Access Compliance Report Public Rights-of-Way (Curb Ramps)

Main Street: OLIVE_AVE Cross Street: ORANGE_OLIVE_RD Location: E

ADA ID: RPAT220127121939 Ramp Type:Type 1 - Perpendicular Initial Pass/Fail: Pass Overall Compliance: No Severity Score: 9

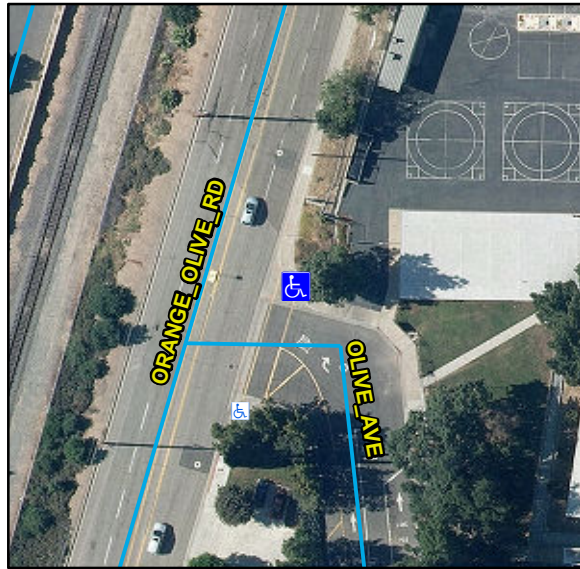
Compliance	Description	Data	Compliance	Description	Data
N/A	Ramp Length (in)	48	N/A	Flare Type LT	
Yes	Ramp Width (in)	50			Sloped
Yes	Ramp Run Slope (%)	7.7	Yes	Flare Slope LT (%)	3.4
Yes	Ramp Cross Slope (%)	0.6	N/A	Flare Traversable LT	Yes
N/A	Landing Present	Yes	N/A	Flare Type RT	
N/A	Landing Length (in)	47			Sloped
Yes	Landing Width (in)	50	Yes	Flare Slope RT (%)	5.4
Yes	Landing Run Slope (%)	0.6	N/A	Flare Traversable RT	Yes
Yes	Landing Cross Slope (%)	0.8	Yes	DWS Provided	Yes
N/A	Landing Movement Obstructed?	Yes	Yes	DWS Contrast	Yes
	Landing Movement Type	Curb	Yes	DWS Length (in)	39
N/A	Landing Shared	Yes	Yes	DWS Full Width	Yes
N/A	Clear Space	N/A	Yes	DWS Offset Left (in)	0
N/A	Clear Space To Crosswalk (in)	N/A	Yes	DWS Offset Right (in)	N/A
N/A	Marked Crosswalk 1	Yes	N/A	Marked Crosswalk 2	N/A
	Crossing 1 Direction	SW		Crossing 2 Direction	N/A
	Marked Crosswalk 1 Width (in)	118		Marked Crosswalk 2 Width (in)	N/A

Yes	Ramp Inside Crosswalk 1	Yes	Yes	Ramp Inside Crosswalk 2	N/A
	Crossing 1 Slope (%)	5.7		Crossing 2 Slope (%)	N/A
	Crossing 1 Cross Slope (%)	1.7		Crossing 2 Cross Slope (%)	N/A
Yes	Gutter Ponding	No	No	Curb Slope	10.1
Yes	Gutter Lip Height (in)	0		Road Run Slope (%)	N/A
No	Gutter Run Slope (%)	9.7		Road Cross Slope (%)	N/A
Yes	Gutter Cross Slope (%)	0.5			
Yes	Overall Surface Condition: Acceptable		Yes	Perp Joint Present	Yes
	Cross Gutter Present?	Yes		Spandrel Present?	Yes
	Replace Cross Gutter?	No		Replace Spandrel?	No

Remove & Replace Entire Ramp. Remove & Replace Gutter.

R304.2.2, R304.2.1, R304.5.4, STD 1115
